Subject: Redondo Beach Energy Project (12-AFC-03)
South Coast Air Quality Management District's Request for Information

Subject: Redondo Beach Energy Project Permit Application (Facility ID# 115536)

AES Redondo Beach, LLC (AES) is submitting this letter in response to the South Coast Air Quality Management District's (AQMD) June 7, 2013 request for additional information needed to complete the evaluation of the Redondo Beach Energy Project (RBEP). This letter presents AES's responses to the requested information.

FIGURE 1
Class II Area within 50-km of RBEP

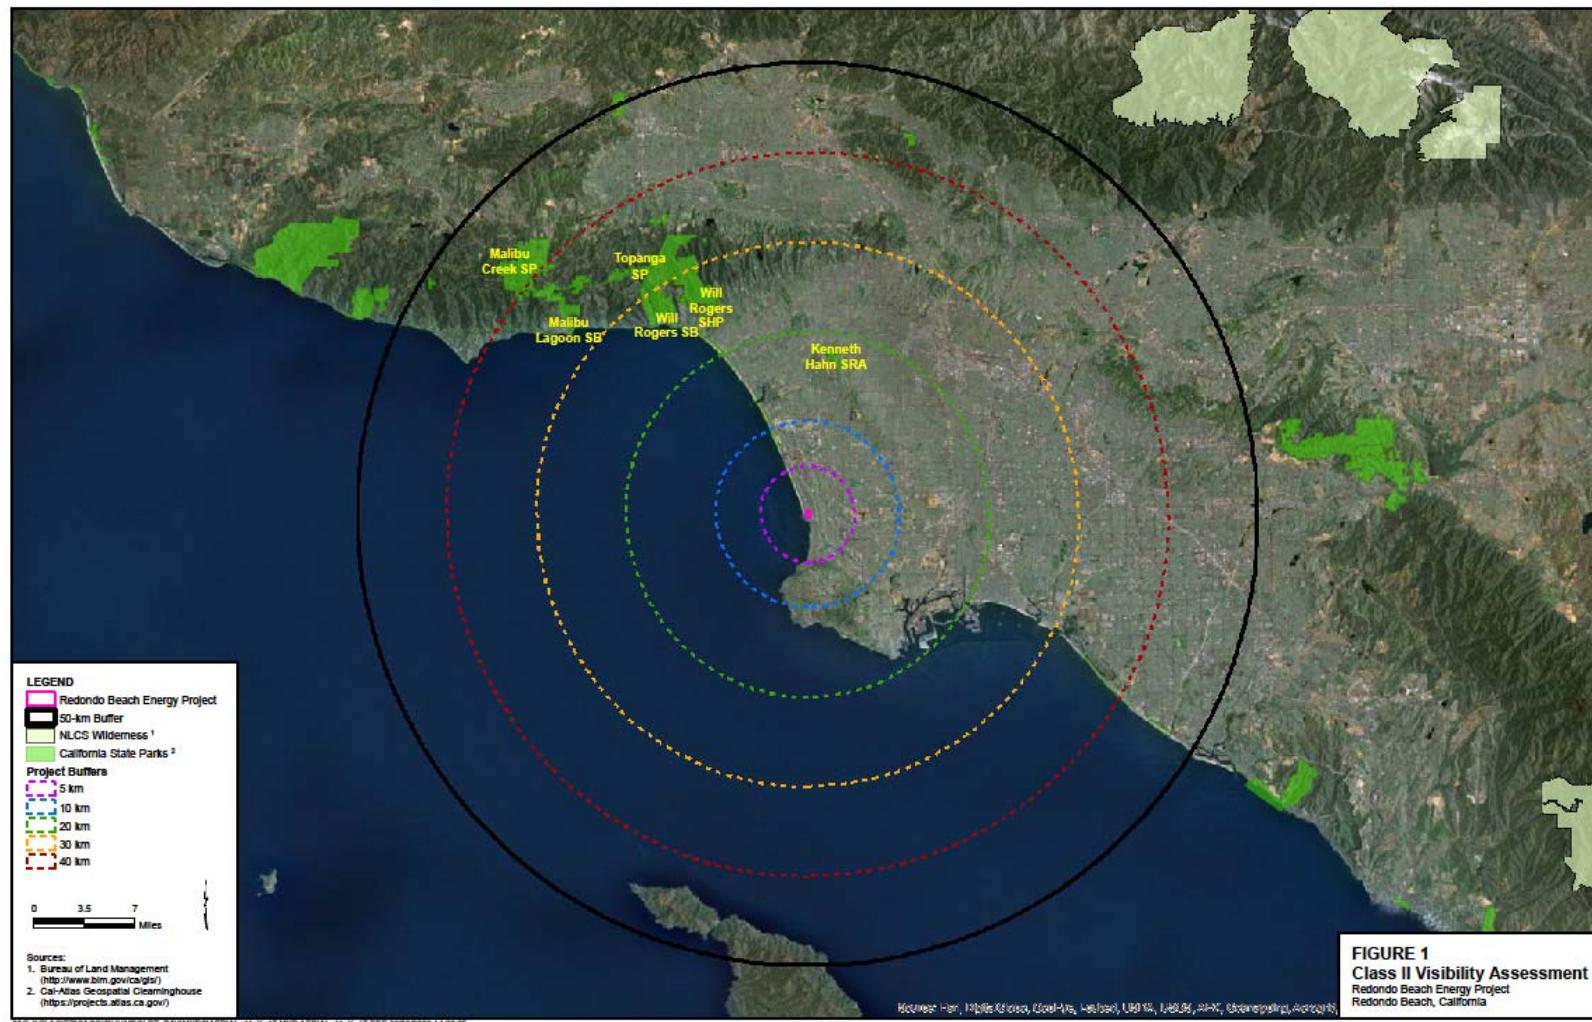
Please provide a visibility analysis for Class II areas within 50 km of the project using the VISCREEN plume modeling program.

A survey of California State Parks and Wilderness areas designated as Class II areas was conducted within 50-km of RBEP. The results of this survey were summarized and presented to the AQMD staff for review and approval. The Class II areas identified and approved by the SCAQAMD for inclusion in the Class II visibility analysis are presented in Table 1 below and shown on Figure 1.

Following the approach above, Table 2 summarizes the VISCREEN Tier I modeled results for each Class II area shown in Table 1. The maximum modeled values for ΔE and contrast are presented for inside the area analyzed, regardless of the VISCREEN modeled lines of sight for the observer.
